1   **REFERENCE:**   InterGroup Report, page 1-4 (lines 15-25)

1 **REFERENCE:** InterGroup Report, pages 1-5 to 1-7 and pages 3-4 to 3-11

**Figure 16: Plan 1 (All Gas) vs. Plan 4 (K19/Gas/250MW) at 5.05% Real Discount Rate  
- NPV of Incremental Domestic Costs as Compared to Plan 1 (All Gas) Expected Value  
(\$ Millions)**

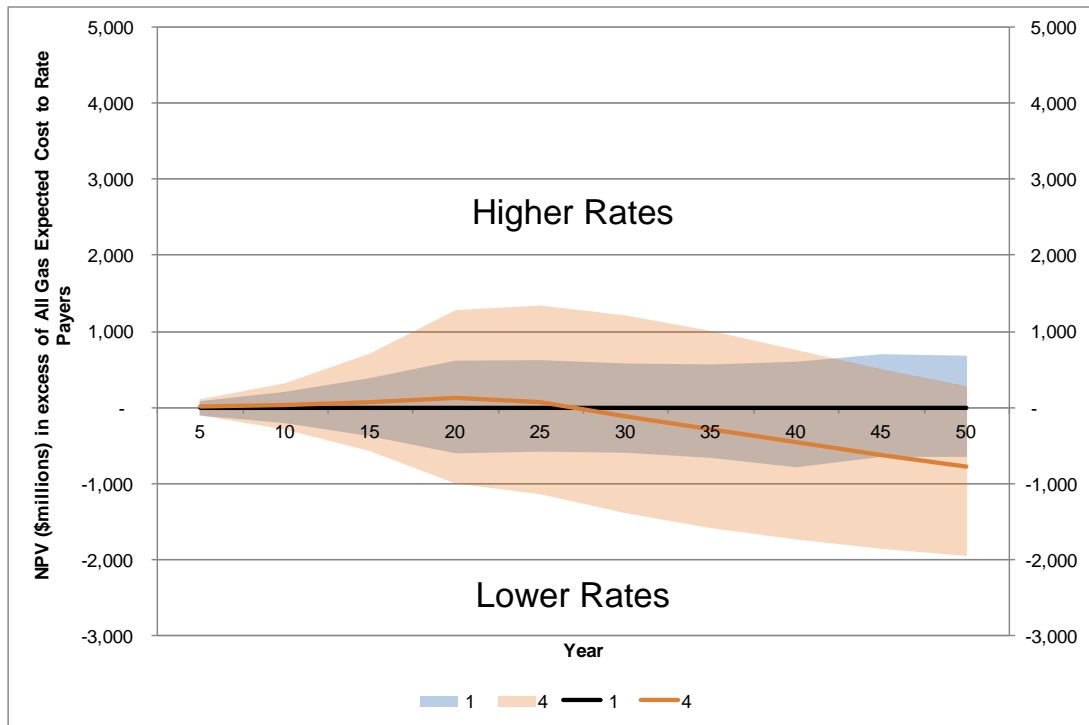
9       a) How has InterGroup satisfied itself that the issues raised on pages 3-7 and D-3  
10       do not present themselves in this NFAT and therefore a more comprehensive  
11       consideration of the impact of Plans with more DSM and/or wind is not required?

- Figure 16 in Mr. Bowman's Appendix C<sup>1</sup> indicates that the ratepayer impacts of these two plans at a reasonable discount rate:
  - Do not indicate Plan 4 (K19/Gas/250MW) to be problematic over near term horizons (no expectation of higher rates over Plan 1 (All Gas)); and
  - Substantially favour Plan 4 (K19/Gas/250MW) over horizons longer than 30 years.
